FINAL ADVICE ON TASMANIAN FREQUENCY OPERATING STANDARDS

Advice to the Reliability Panel from NEMMCO regarding Proposed Changes to the Tasmanian Frequency Operating Standards

Figure 1 R6 Availability during period when Basslink out of service

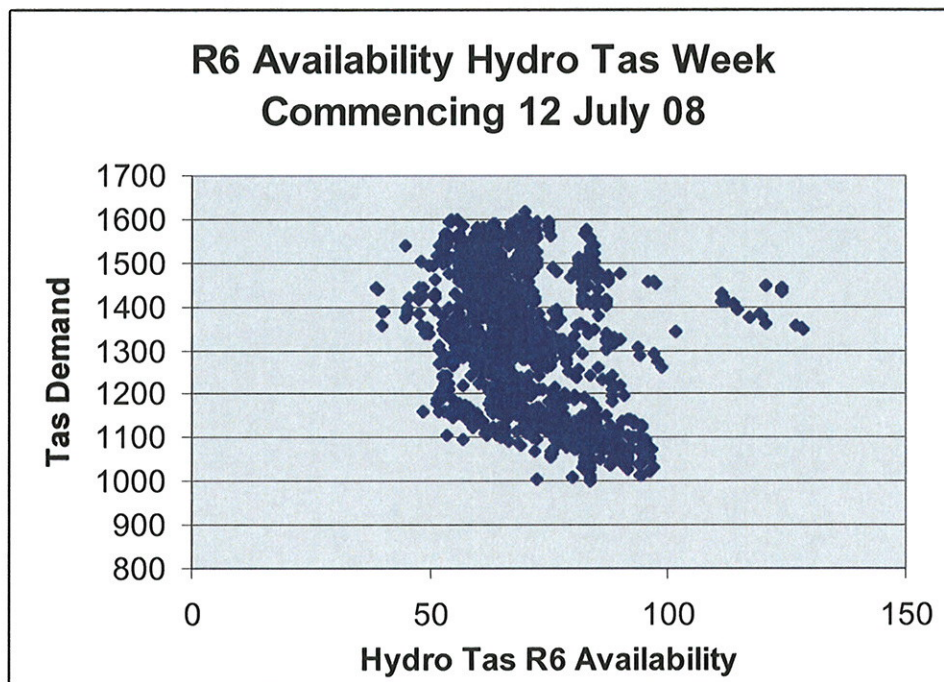
then, in circumstances where fast raise (R6) services cannot be transferred on Basslink, all R6 services will be required to be supplied from Hydro Tasmania plant. A review of the actual availability of these services from Hydro Tasmania when Basslink is out of service has shown that the actual availability rarely exceeds 100 MW (refer figure 1).

However as shown in Attachment 1 the requirement for R6 service to cover the loss of the higher efficiency thermal generating plant (at 210MW) under the standard proposed by Alinta would range from about 304 MW at light load to about 135 MW at high load.

Figure 2 L6 Availability during period when Basslink out of service

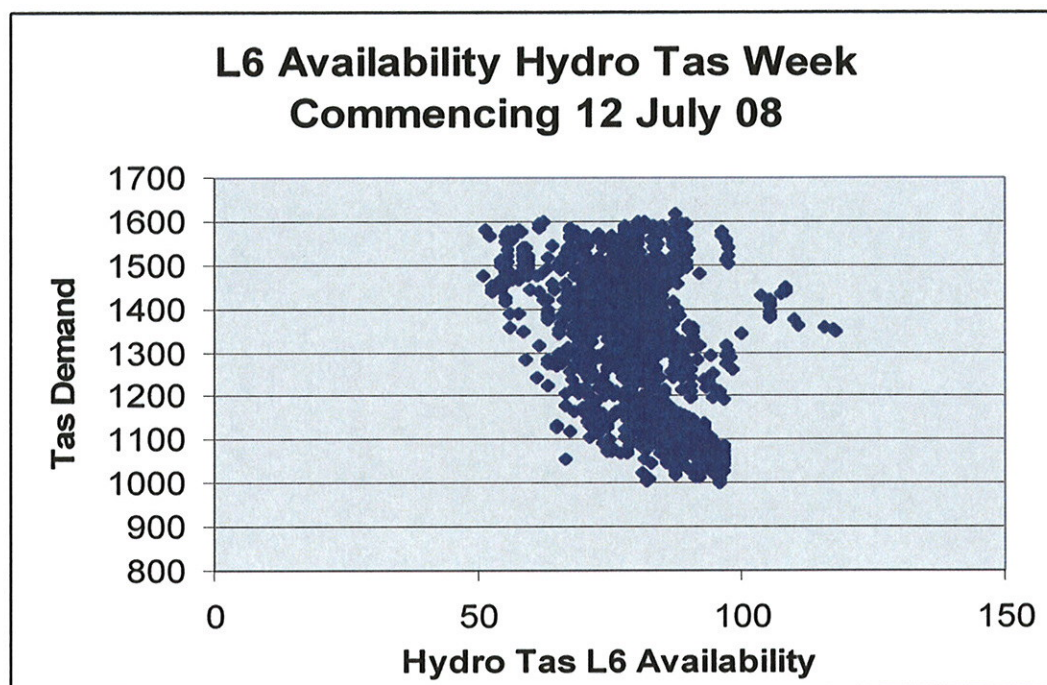
As can be seen in Figure 2 the Fast Lower (L6) Service currently available from hydro plant in Tasmania rarely exceeds 100 MW. Thus in circumstances where all higher efficiency

plants are either unavailable or not providing lower services then it would be very difficult to meet this requirement under light load conditions.⁷
